HISTORIC AND DESIGN REVIEW COMMISSION

February 05, 2020

HDRC CASE NO: 2020-030
ADDRESS: 206 CAMARGO
LEGAL DESCRIPTION: NCB 924 BLK 5 LOT N 134 FT OF 2
ZONING: RM-4, H
CITY COUNCIL DIST.: 1
DISTRICT: Lavaca Historic District
APPLICANT: Adan Ochoa/AO Design, LLC
OWNER: TAVITAS MICHAEL A & REBECCA S
TYPE OF WORK: Front porch reconstruction, amendment to a previously approved design
APPLICATION RECEIVED: January 17, 2020
60-DAY REVIEW: March 16, 2020
CASE MANAGER: Huy Pham

3 EAST ELEVATION
Scale: 3/16" = 1'-0"

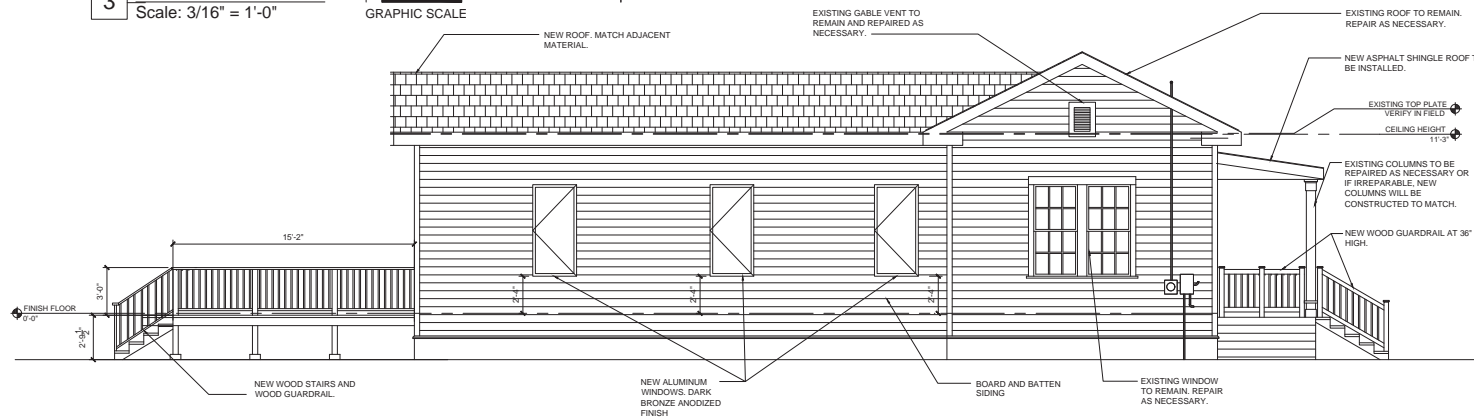
- f. NEW TRANSOM WINDOWS – The applicant has proposed to install two fixed wood transom windows on the east side elevation on the historic portion of the structure to accommodate an interior bathroom. Per the Guidelines for Exterior Maintenance and Alterations 6.A.i., applicants should avoid creating new primary entrances or window openings on the primary façade or where visible from the public right-of-way. Staff finds that the proposed location of the new openings is visible from the right-of-way. Per the Guidelines for Exterior Maintenance and Alterations 6.B.vii., non-historic incompatible windows should be replaced with windows that are typical of the architectural style of the building. Staff finds that the proposed window size and configuration are atypical to the historic structure and should instead feature a one-over-one wood sash window that adheres to the *Standard Specifications for Windows in Additions and New Construction*. The applicant may consider installing wood window screens or an interior furr wall to accommodate the bathroom.

3. Staff does not recommend approval of item #3, the installation of two new transom windows on the side elevation based on siding d. The applicant may resubmit a design that adheres to the *Standard Specifications for Windows in Additions and New Construction*. The applicant may consider installing wood window screens or an interior furr wall to accommodate the bathroom.

1 SITE PLAN Scale: 1/8" = 1'-0"

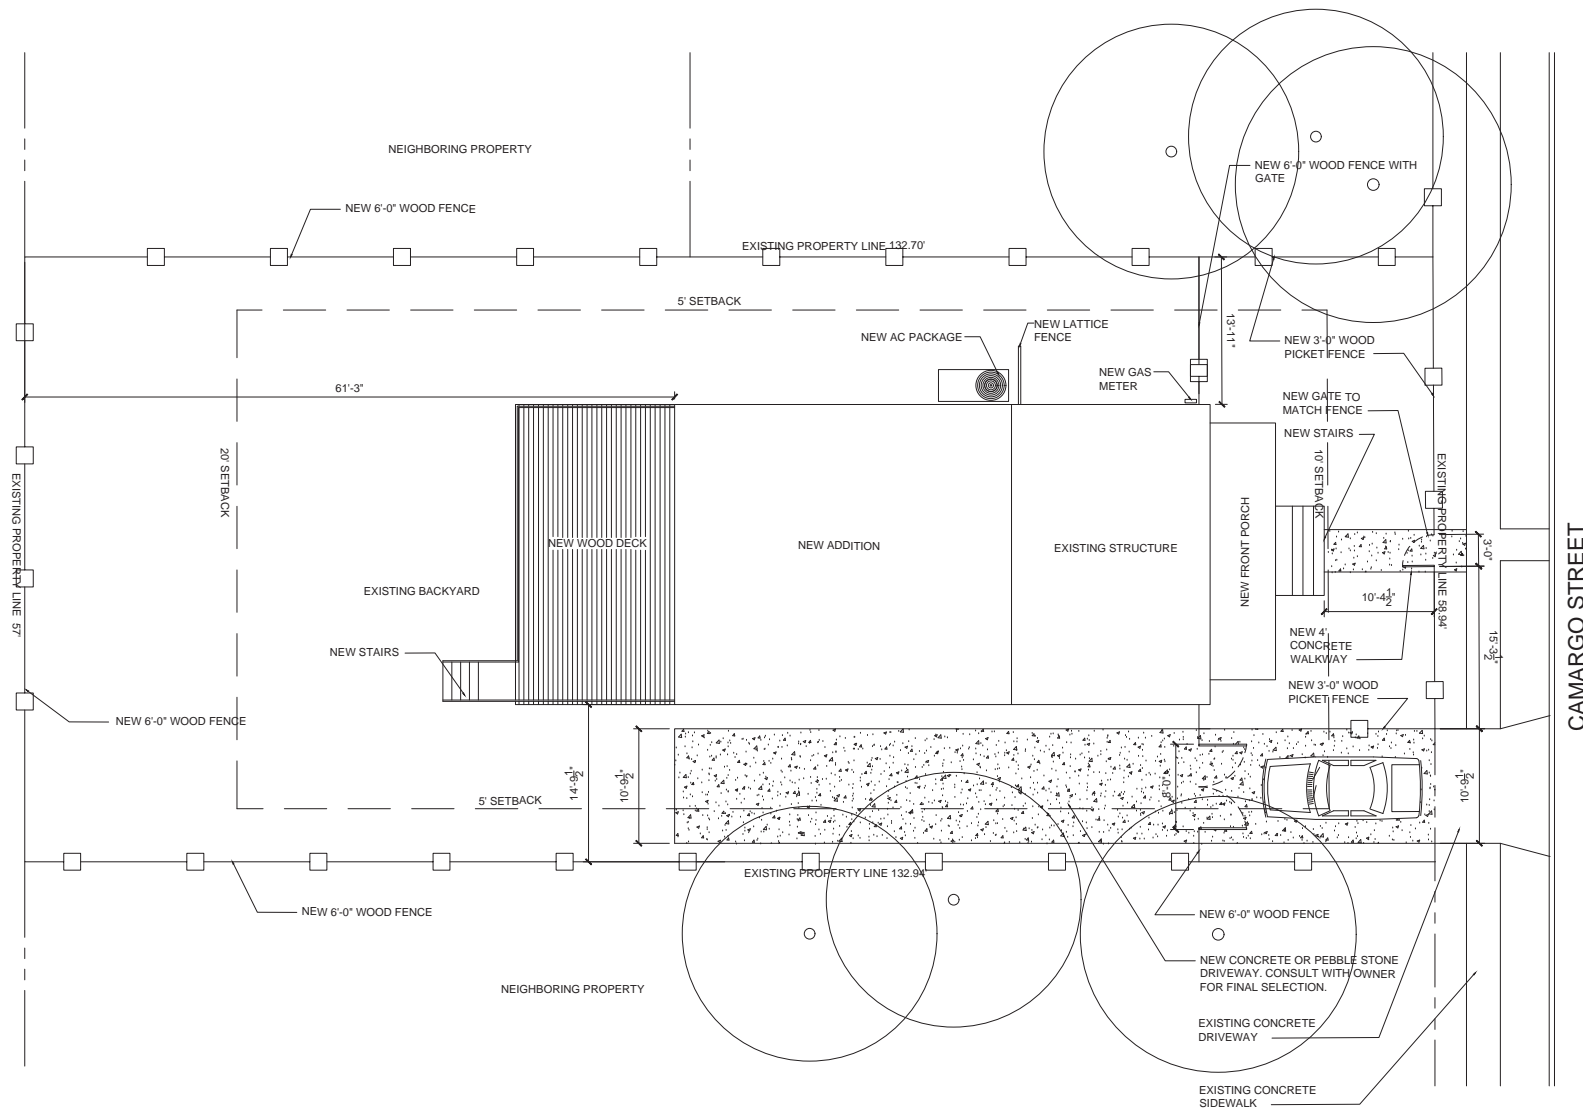
- e. REAR DECK – The applicant has proposed to install a rear deck to feature a 15' x 28' footprint, with simple wood railing and steps. Per the Guidelines for Exterior Maintenance and Alterations 7.B.iv., applicants should design replacement elements, such as stairs, to be simple so as to not distract from the historic character of the building and avoid adding new elements and details that create a false historic appearance. Staff finds that the rear deck should feature an inset to the side wall planes instead of flush as proposed on the site plan to reduce visibility from the front right-of-way. The rear deck is otherwise generally consistent with the Guidelines.

- ii. That the porch deck feature 1 x 3 wood tongue-and-groove members laid perpendicular to the front façade plane.
2. Staff recommends approval of item #2, the construction of a rear deck based on finding c with the stipulation that an inset is incorporated on each side elevation wall plane.
